**COUNTY OF WESTCHESTER
NEW YORK**

ADDENDUM NO. 3

CONTRACT NO. 20-502

**LOW RISE BUILDING RENOVATIONS AND
HVAC IMPROVEMENTS - PHASE II
110 DR. MARTIN LUTHER KING, JR. BOULEVARD
WHITE PLAINS, NEW YORK**

| FINISH PLAN - 2ND FLOOR - CENTRAL WING | | 52-11-A-1840-0 | |

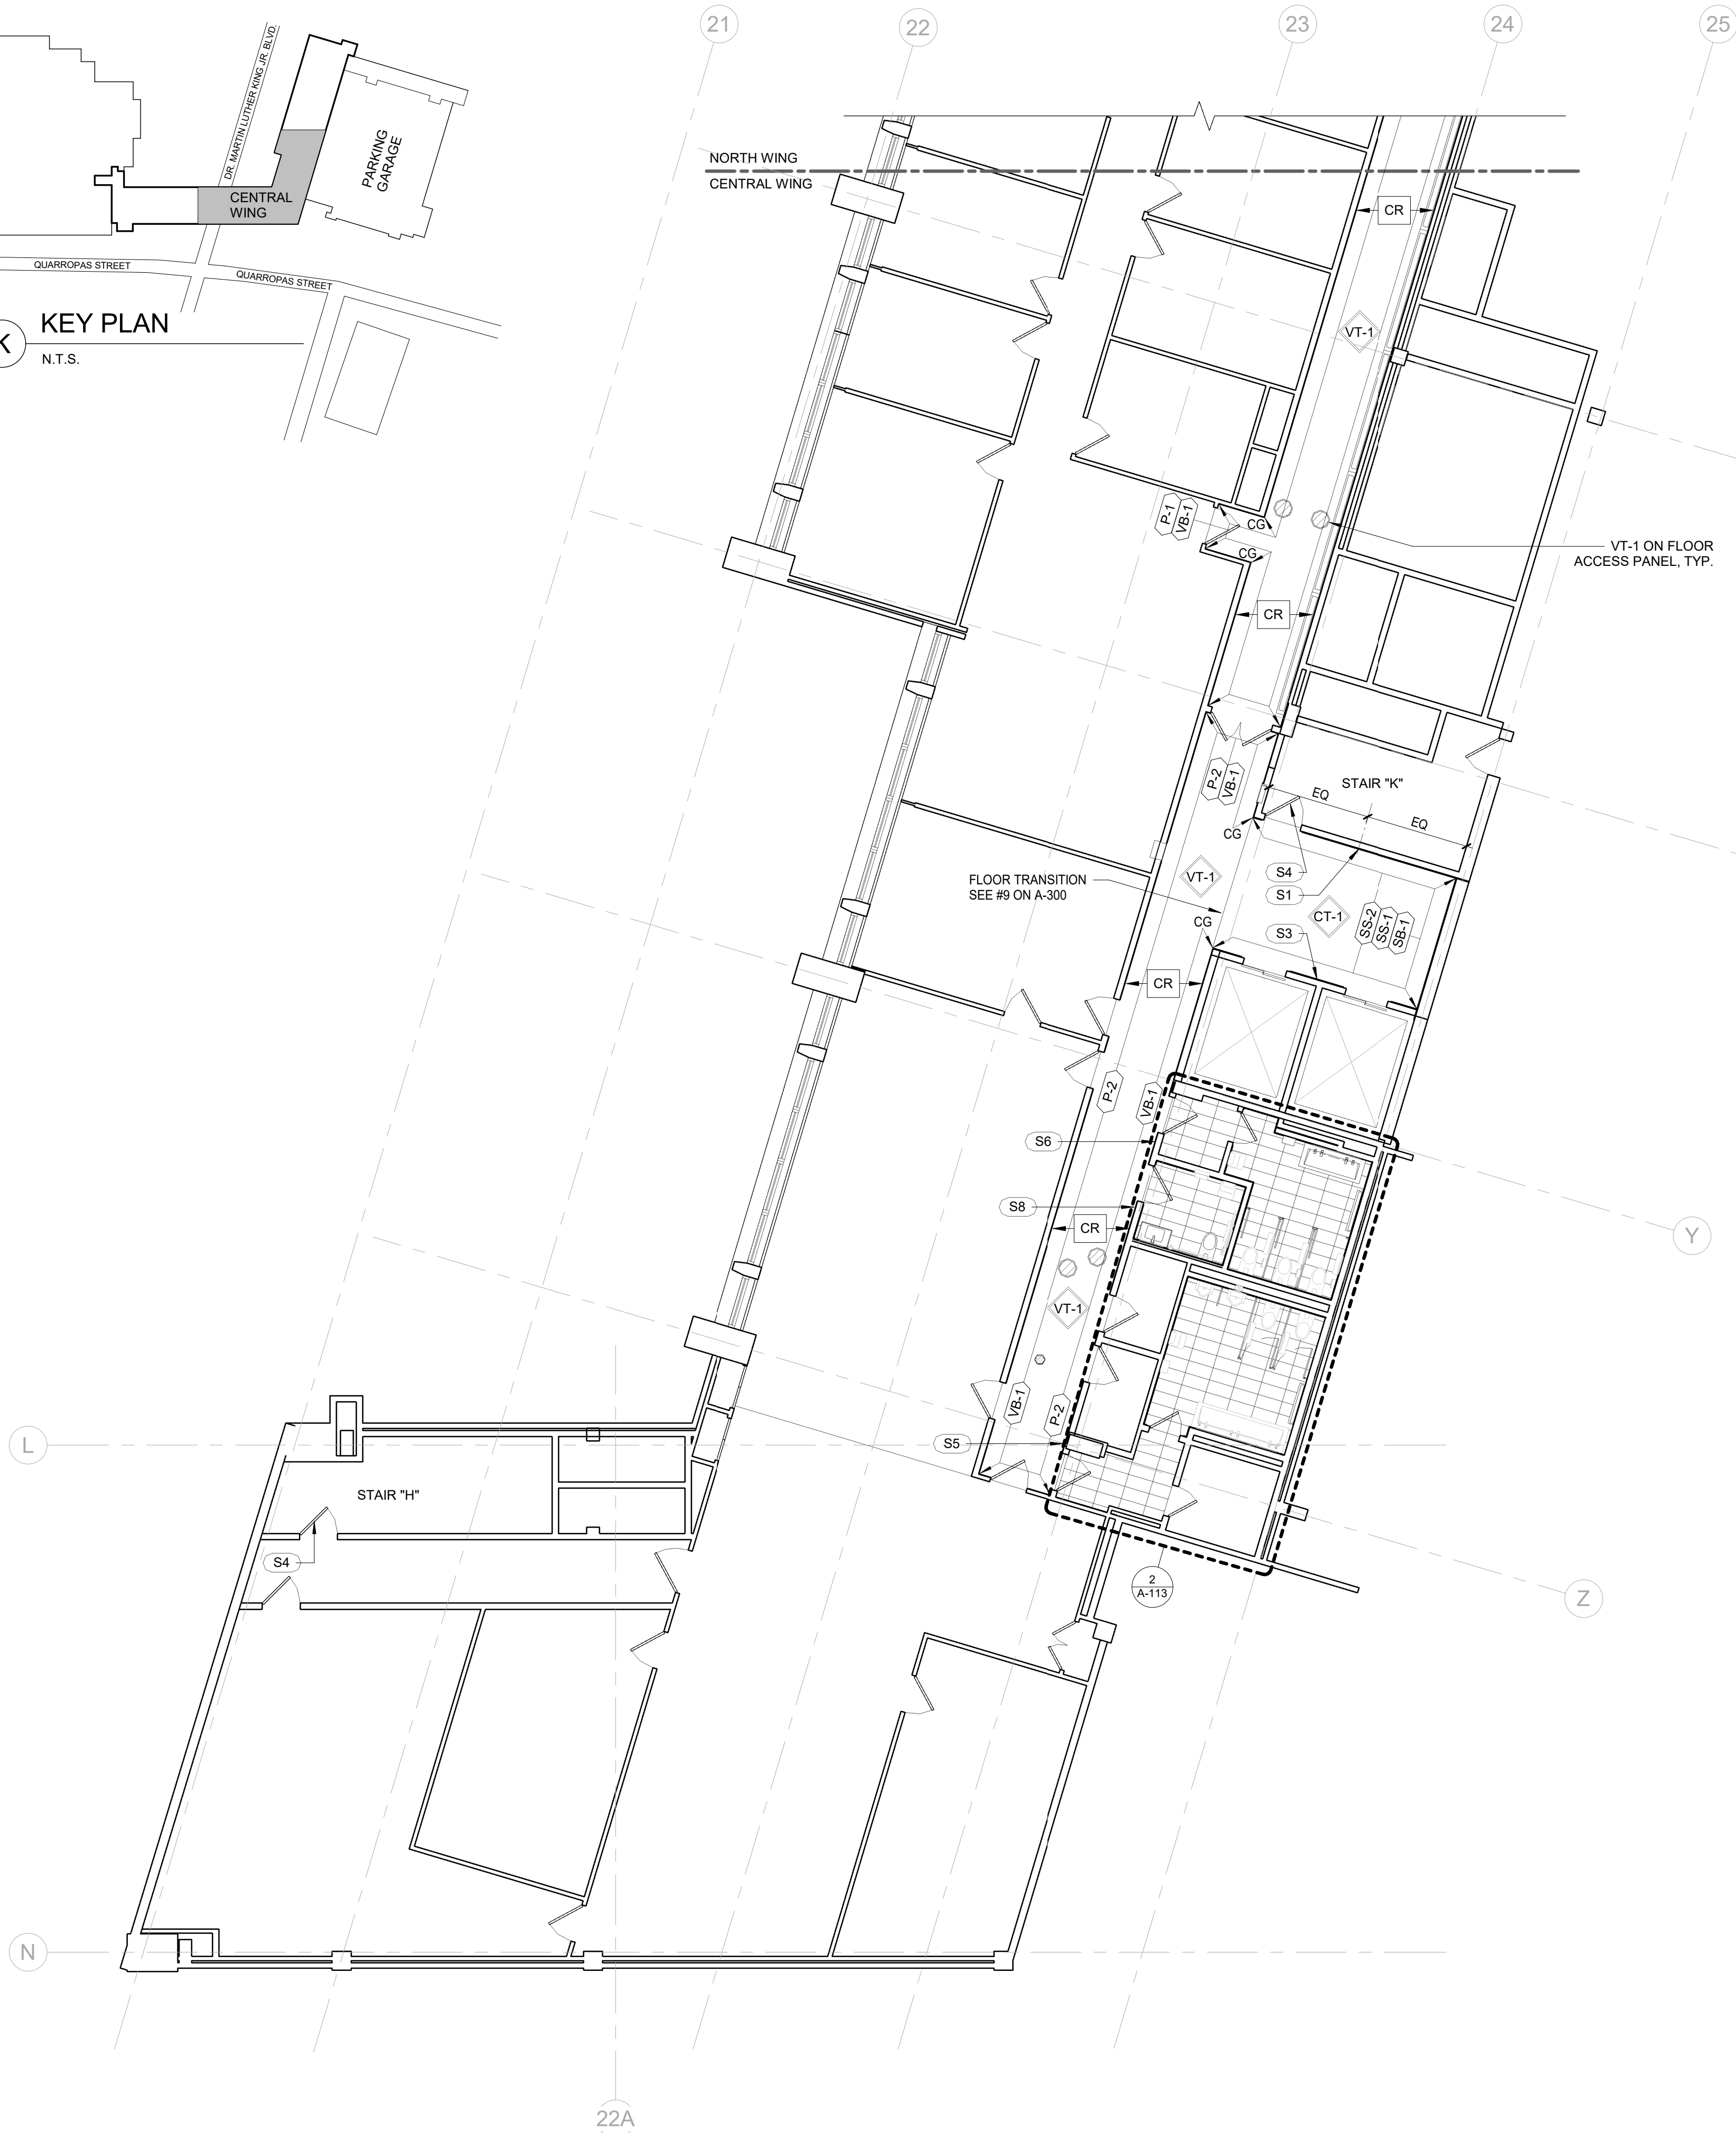
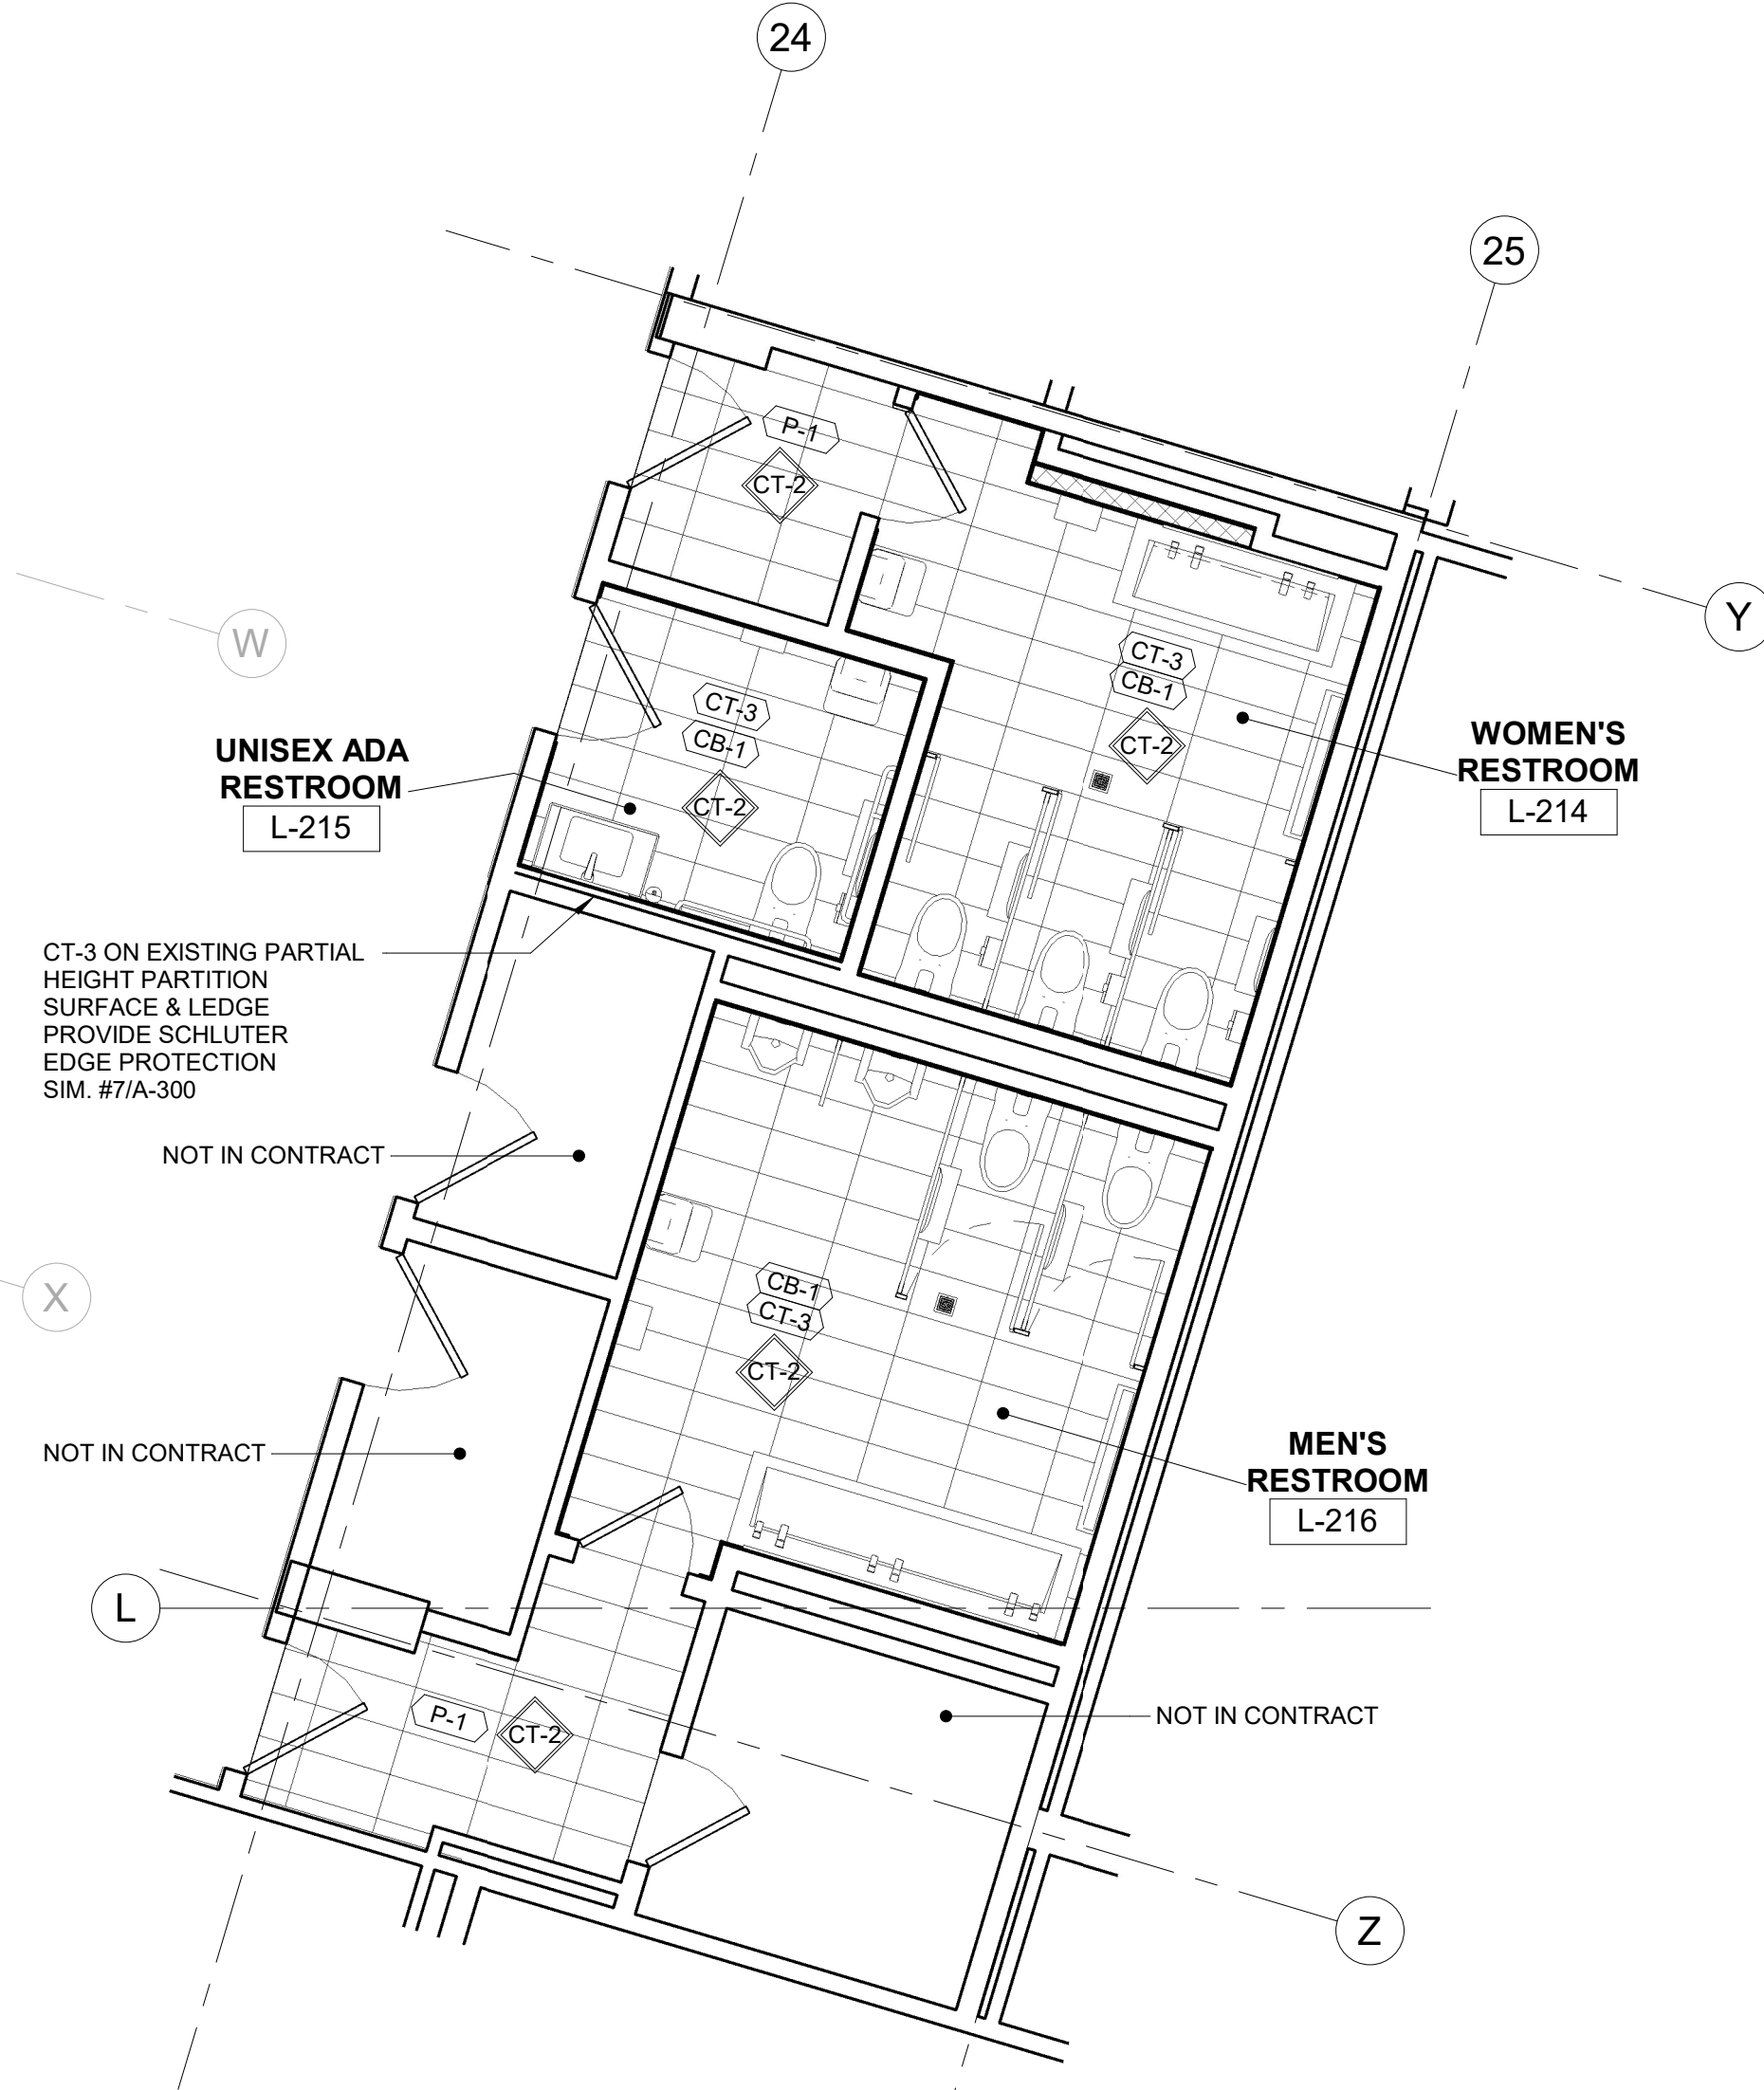
| Q16 | How many signs of each type are we to include Ref. DWG. A-303, signage schedule Please provide a signage schedule. | <p>Refer to drawings issued as part of Addendum #3 Please find revised finish plans, A-111 through 114 and signage details on A-303. Signage symbol S-# has been added on finish plans. Signage type, details, note, etc. have been modified on A-303.</p> |
